PROJECT TITLE: **Old Town Gallery,**
ZONE MAP/DRG. FILE # J-13
DRB#: NA EPC#: NA WORK ORDER#: NA

**Re: Our Old Town Gallery -424 San Felipe NW, Albuquerque, NM
(Zone Atlas Map J-13)**

**Re: Old Town Gallery/Retail & Living Space, Grading and Drainage Plan
Engineer's Stamp dated 9-1-2011 (J13/D091)**

Hydrograph Calculations for storage (Basin 2)

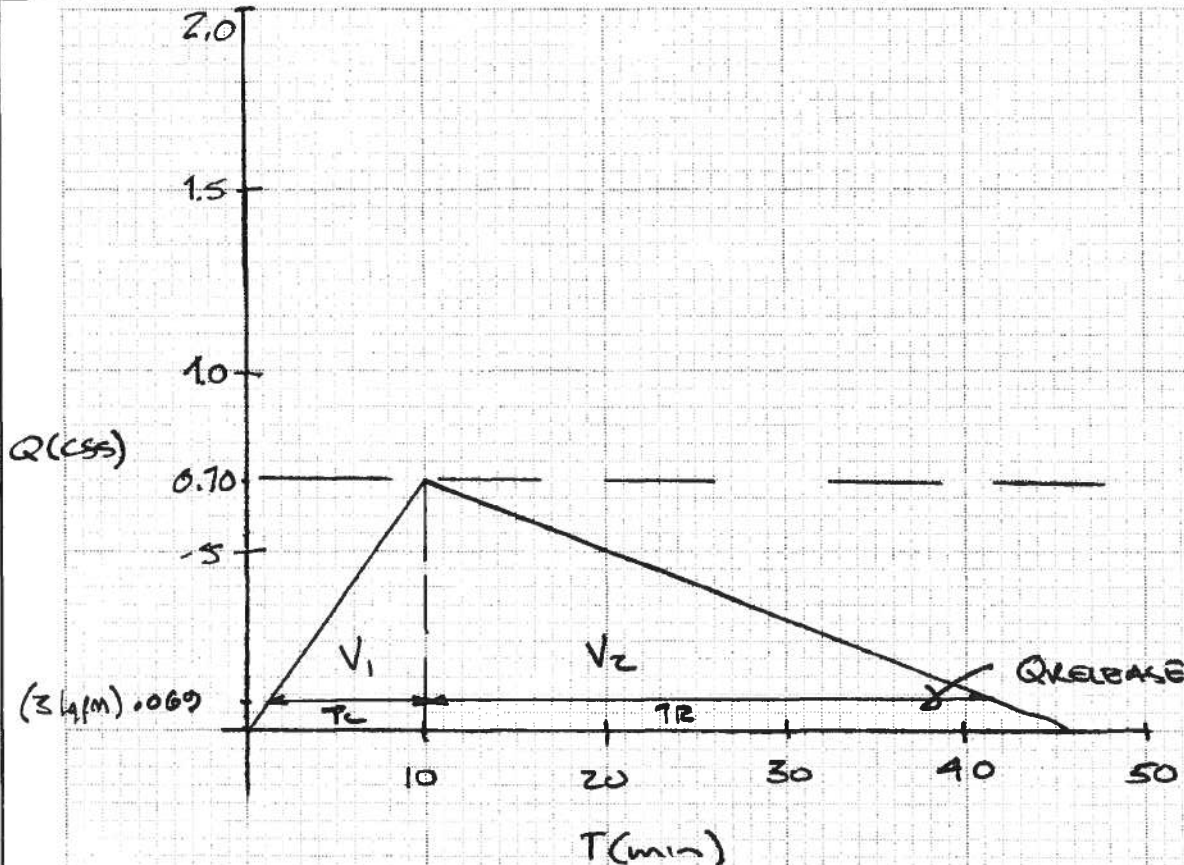
Comment 4): Due to the small size of the basin & pond, pond routing calculations were not provided. I did however provide the hydrograph for the pond showing the Q release via pump and the related required and provided volumes.

$$V_1 = \frac{1}{2} Q_{100} T_c = \frac{1}{2} (0.70) 10 \text{ min} (60) = 210 \text{ cfs}$$

$$V_2 = V_{100} - V_1 = 1172 - 210 = 962 \text{ cfs}$$

$$V_2 = \frac{1}{2} (Q_{100}) T_r (60) \Rightarrow T_r = \frac{2V_2}{Q_{100}(60)} = \frac{2(962)}{0.70(60)} = \frac{1924}{42} = 45.8 \text{ min}$$

$$Q_{release} = 31 \text{ gpm} (1/448.83 \text{ gpm/cfs}) = 0.069 \text{ cfs} \quad \text{via hydraulic pump}$$

$$V_{req} = \frac{1}{2} (Q_{100} - Q_R)^2 \frac{(T_r + T_c)}{Q_{100}} (60)$$

$$\frac{1}{2} (0.70 - 0.069)^2 \frac{(45.8 + 10)}{0.70} (60) = 0.199 (4792.86) = 952 \text{ cfs}$$

$$V_{provided} = V_1 + V_2 = 1133 \text{ cfs (see next page)}$$

$$1133 \text{ cfs} \times 7.48 \text{ gal/cfs} = 8475 \text{ gal} \div 31 \text{ gal/min} = 273 \text{ min}$$
